Service Bulletin

Subject: LACK OF POWER / WRENCH LIGHT COMES ON WITH DTCs P0123 / P0222	Bulletin No: 01-017/13
	Last Issued: 07/02/2013

2011-2013 CX-9 with VINs lower than JM3TB*****419830 (produced May 1, 2013)

DTC: P0123:00 TP Sensor No. 1 Circuit High Input.

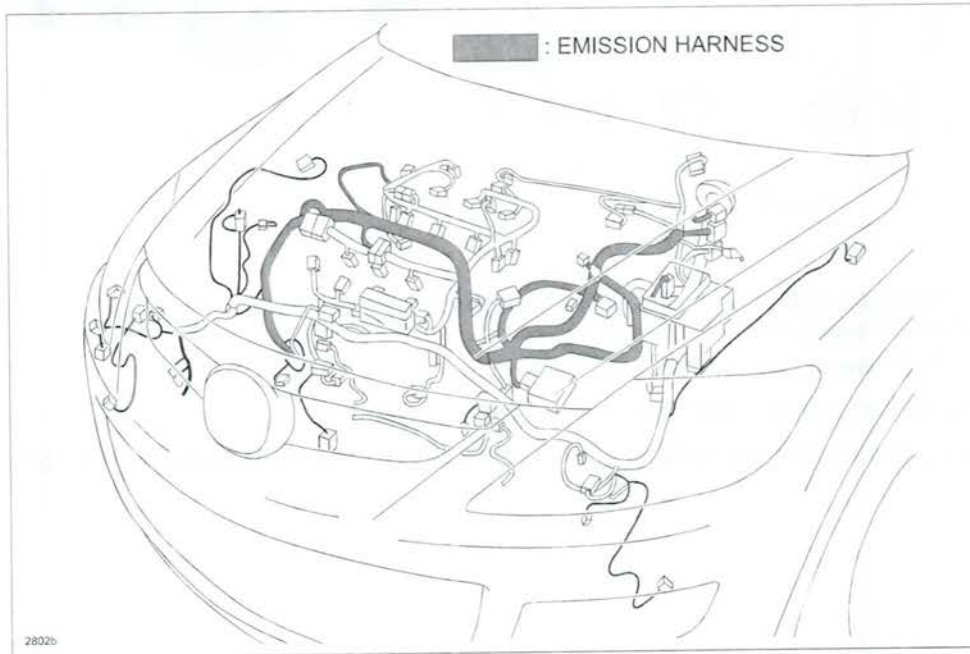
The TP sensor No.1 circuit was flagged as a concern by the PCM indicating a high voltage.

- Connector or terminal malfunction.
- Short to constant voltage supply circuit between throttle body terminal F and PCM terminal 2AN.
- TP sensor signal circuits are shorting each other.
- TP sensor No.1 malfunction.

If no trouble is found during the inspection above, replace the emissions harness with a modified part.
